AL SHURHABIL SCHOOL
UNDER THE COMMANDER'S EMERGENCY RESPONSE PROGRAM
ANBAR PROVINCE, IRAQ

SUSTAINMENT ASSESSMENT

SIGIR PA-08-142
JANUARY 21, 2009

Site Photo 8. Condition of the roof tiles after renovation

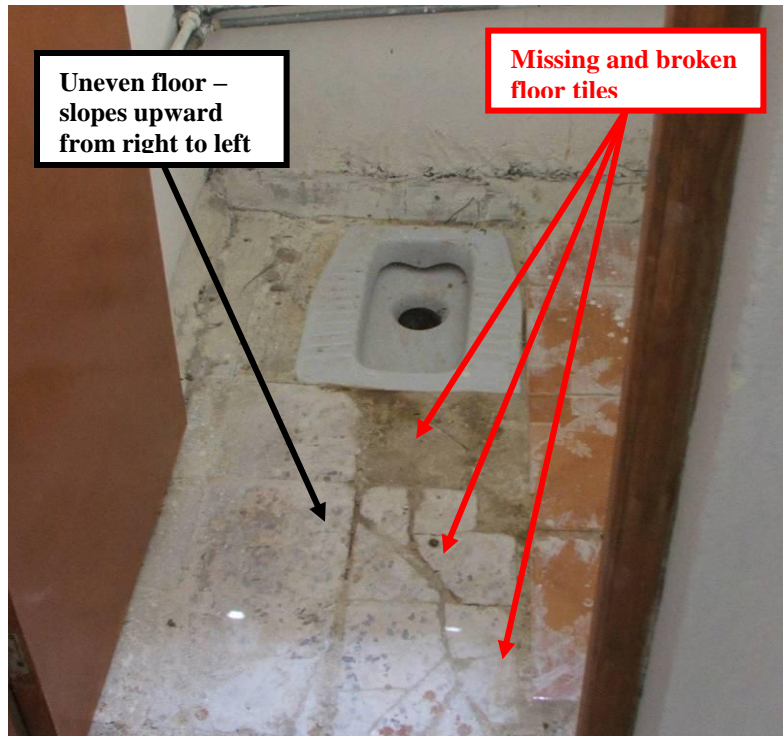
During the site visit, SIGIR observed the construction of the new classroom buildings. The roof tiles appeared to be in good condition throughout the expanse of the roof (Site Photo 8). There were drainage holes at the roof's edges, which will allow water to drain from the roof. The exterior and interior walls appeared to be adequately repaired/replaced (Site Photos 9 and 10). The majority of the interior tile and concrete floor work was good; however, there were areas of missing and broken tiles, as well as, uneven floors (Site Photo 11).
